RALPH G. MASTROMONACO, P.E., P.C.

Re: Village Square Residences and Commercial Development
3095 Albany Post Road
Village of Buchanan, NY

We received comments from James J. Hahn Engineering, PC dated August 18, 2023 and offer the following information:

GARBAGE TRUCK ACCESS PLAN
VILLAGE SQUARE
RESIDENTIAL/COMMERCIAL
CARBONE BROTHERS 3095 LLC
VILLAGE OF BUCHANAN
WESTCHESTER COUNTY, NY
SEPTEMBER 22, 2023

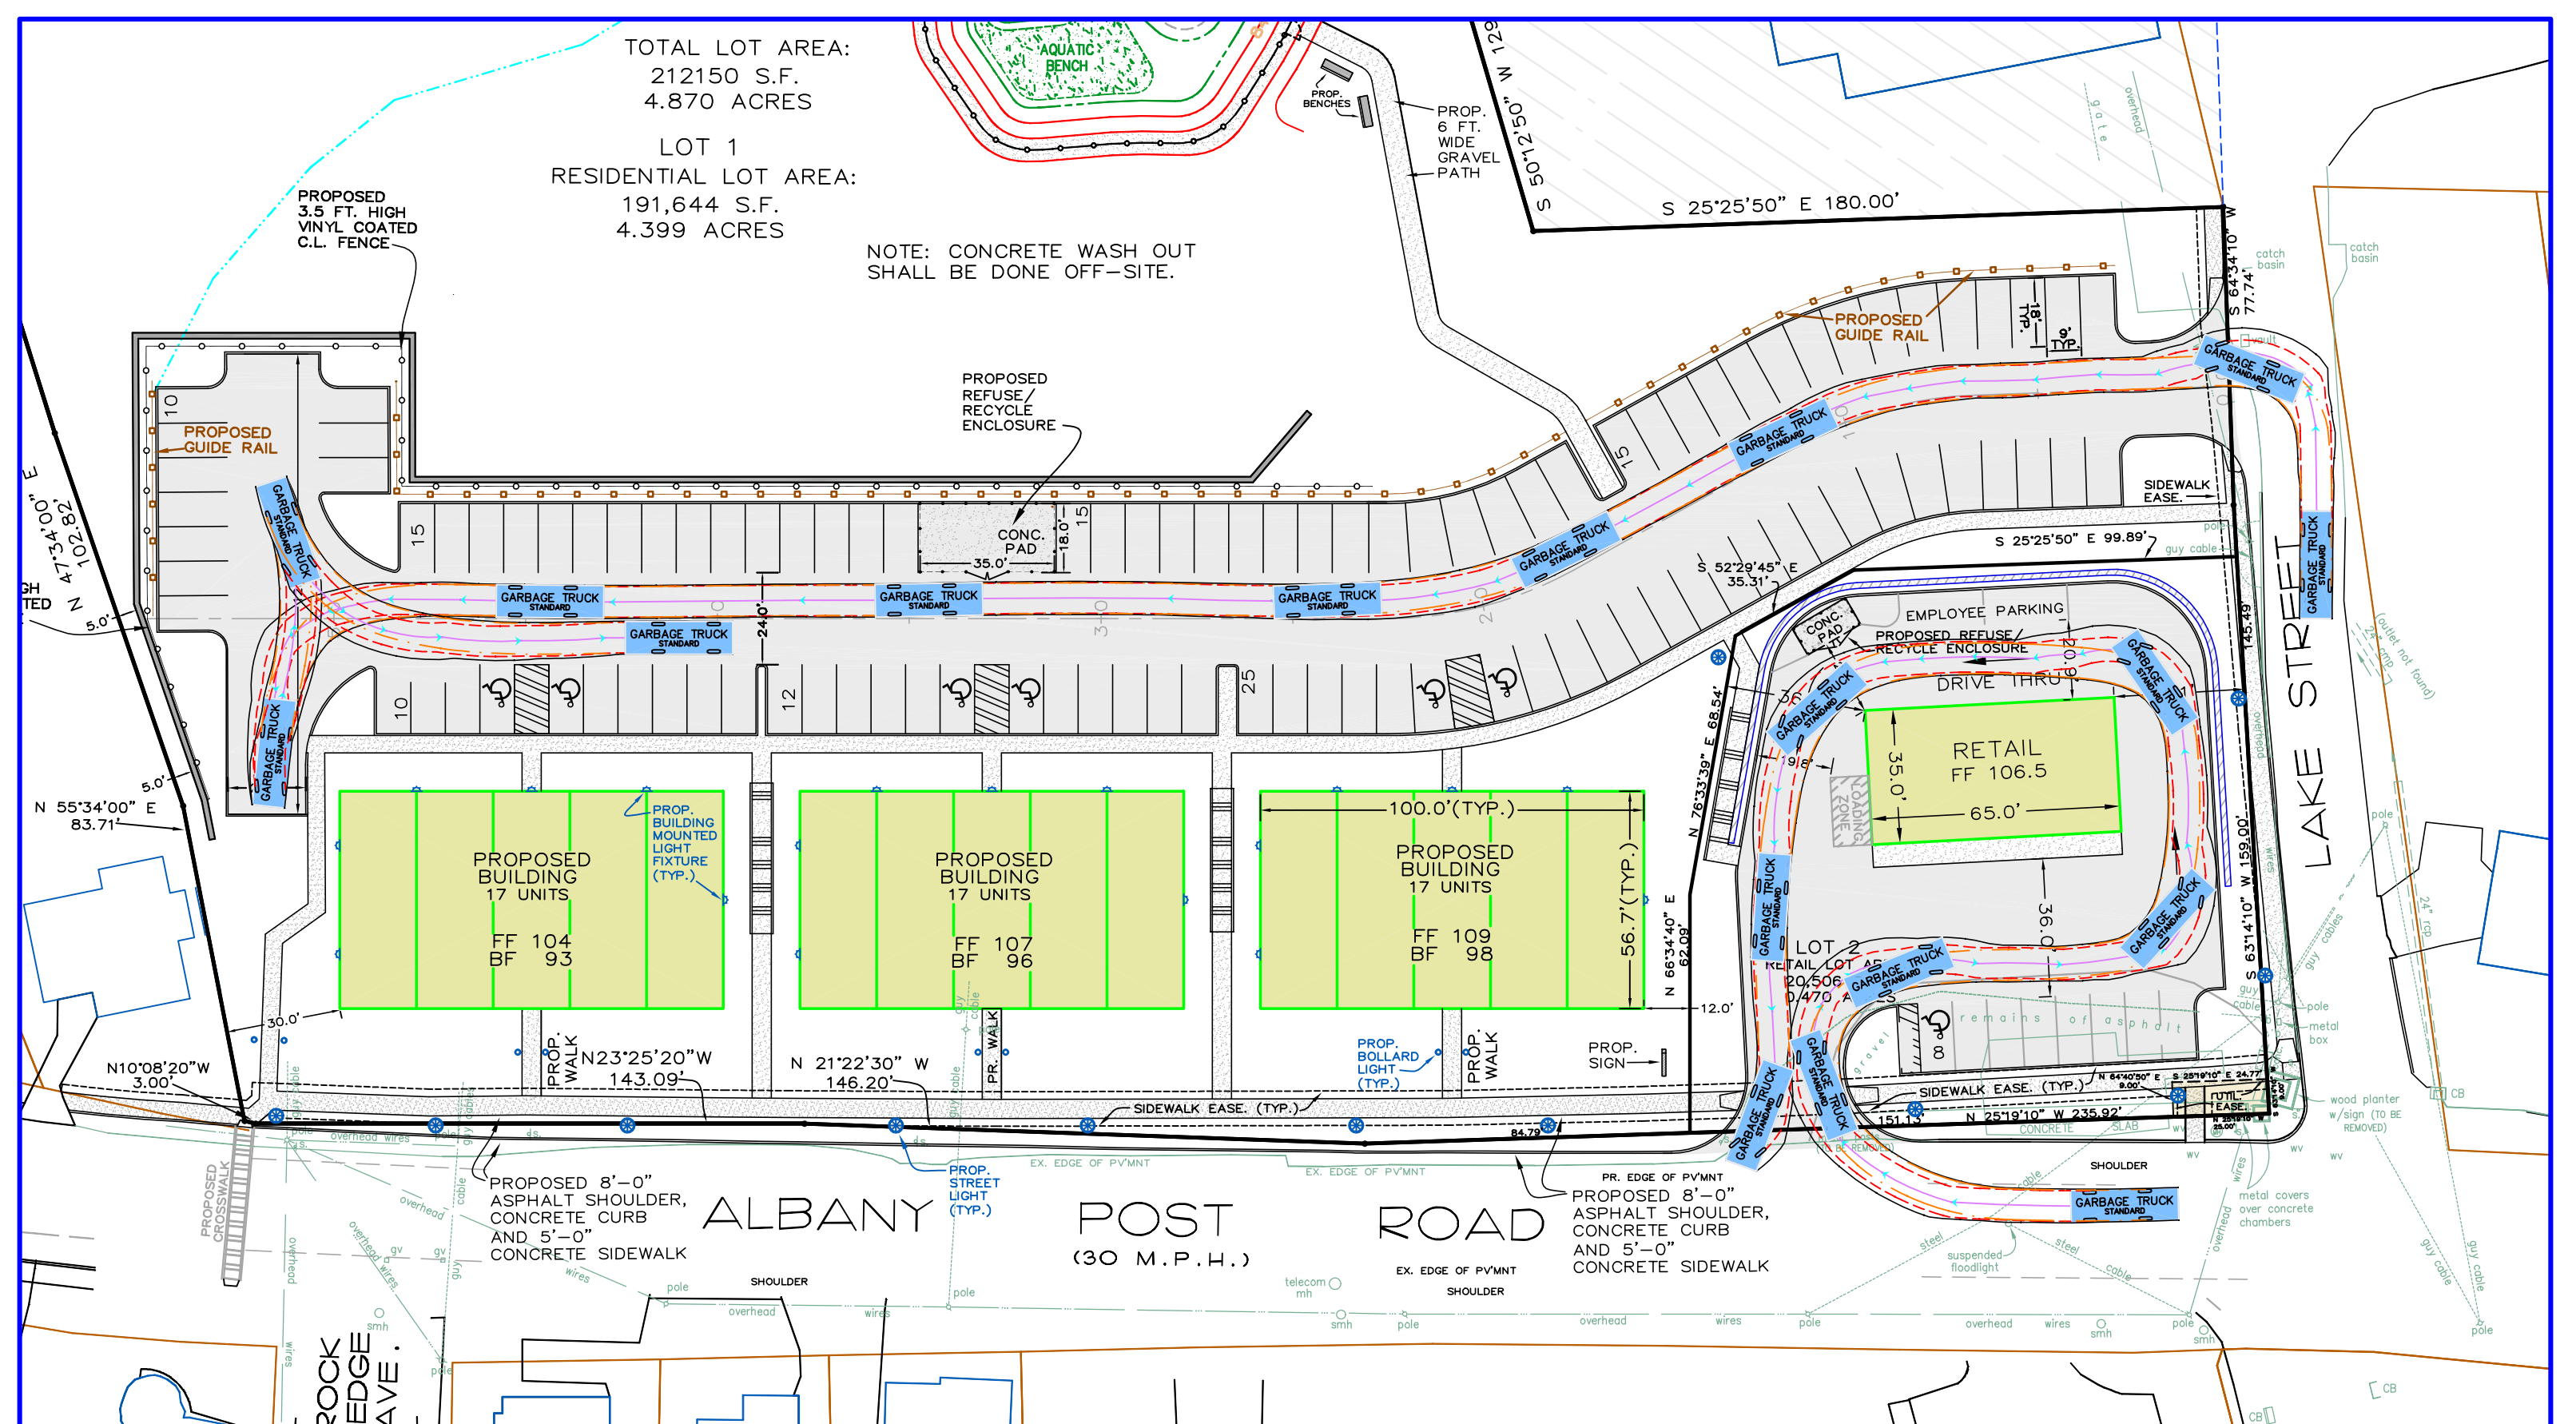
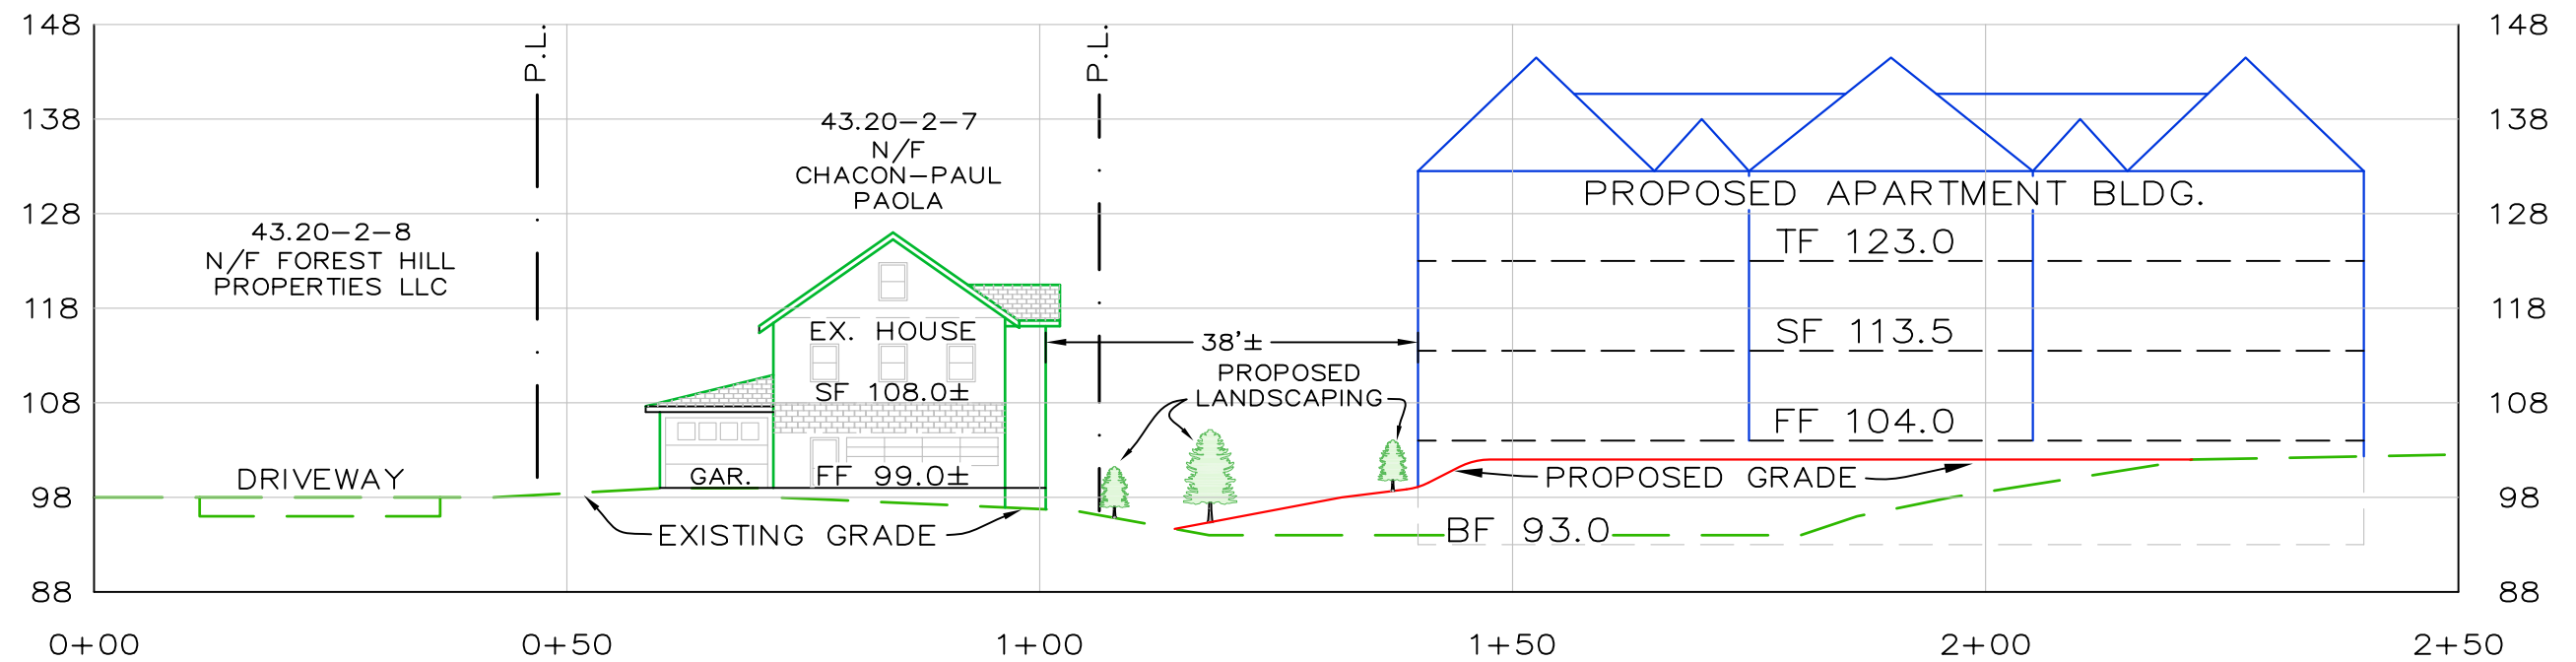
3. As previously mentioned, turning movements should be provided for the proposed refuse collection trucks.

Response: The refuse areas have been consolidated to the center of the site and expanded in size. The private carter will roll-out the dumpsters. Turning Movements are provided.

1 Full Site Landscaping Plan
 C1.01 Scale: 1" = 20'-0"

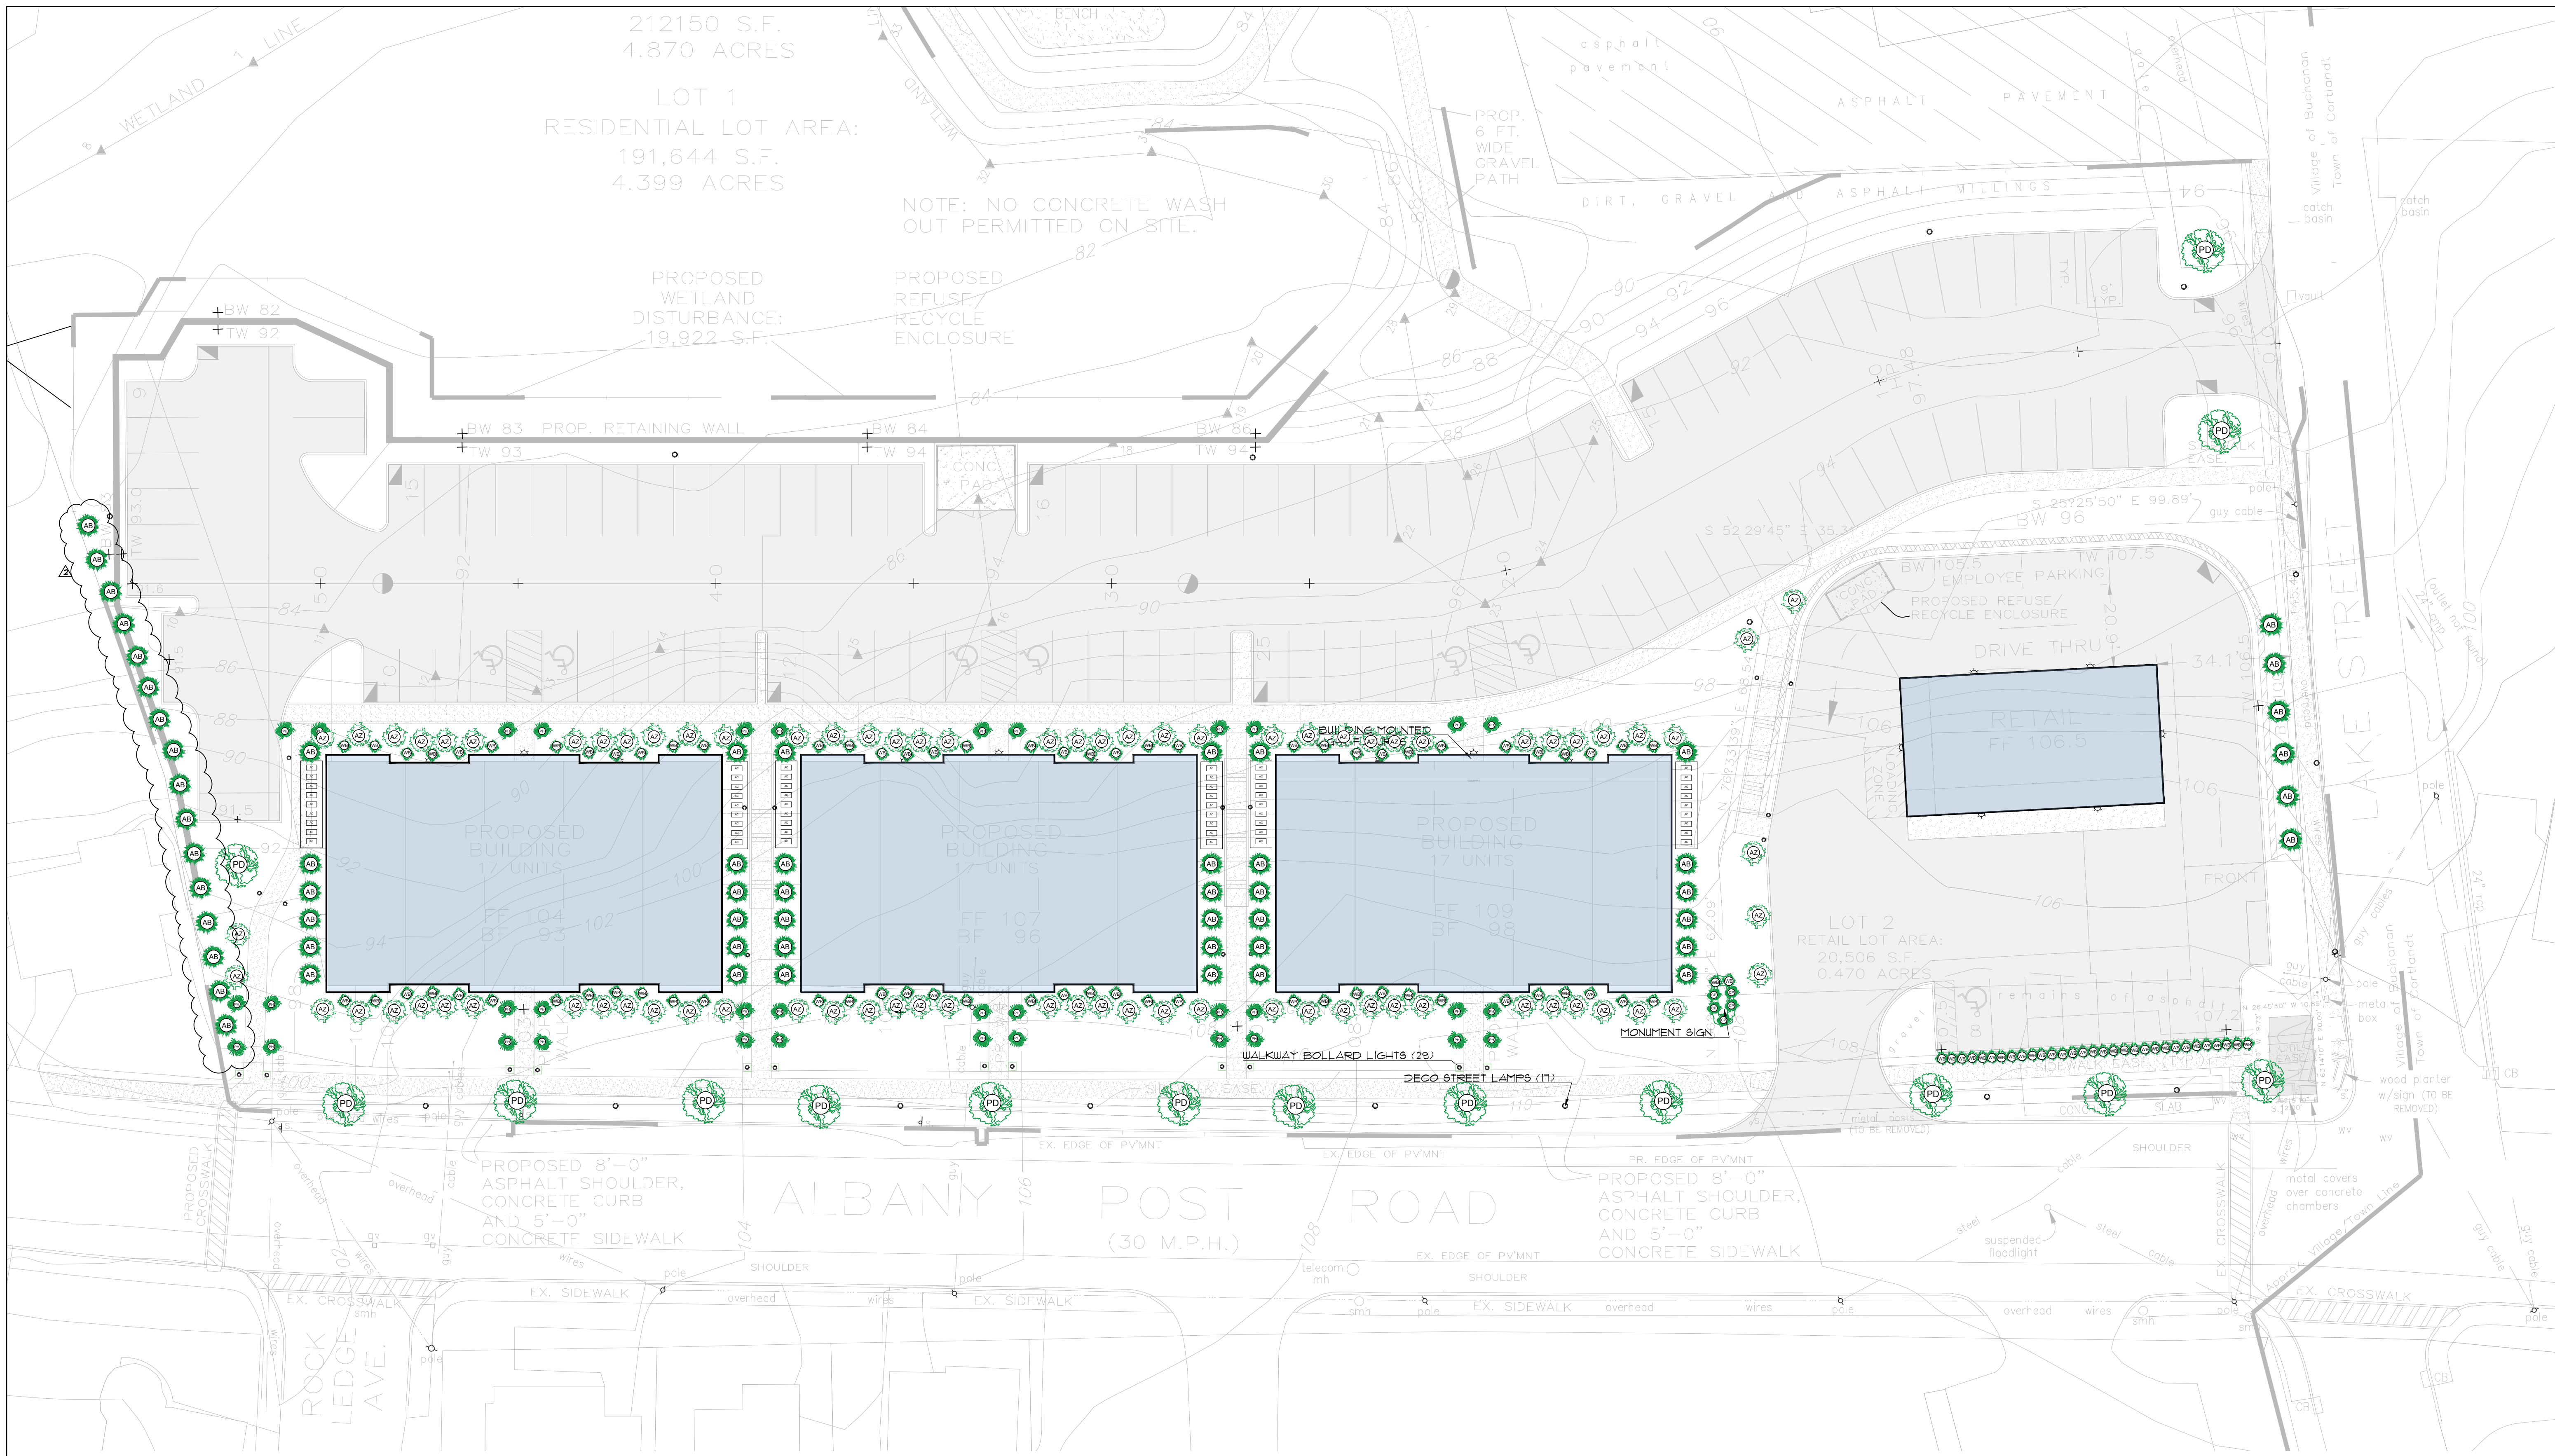
11. As previously mentioned, screening plants should be provided between the parking lot and the school property.

Response: This is shown on the landscape plans by Joe Thompson.
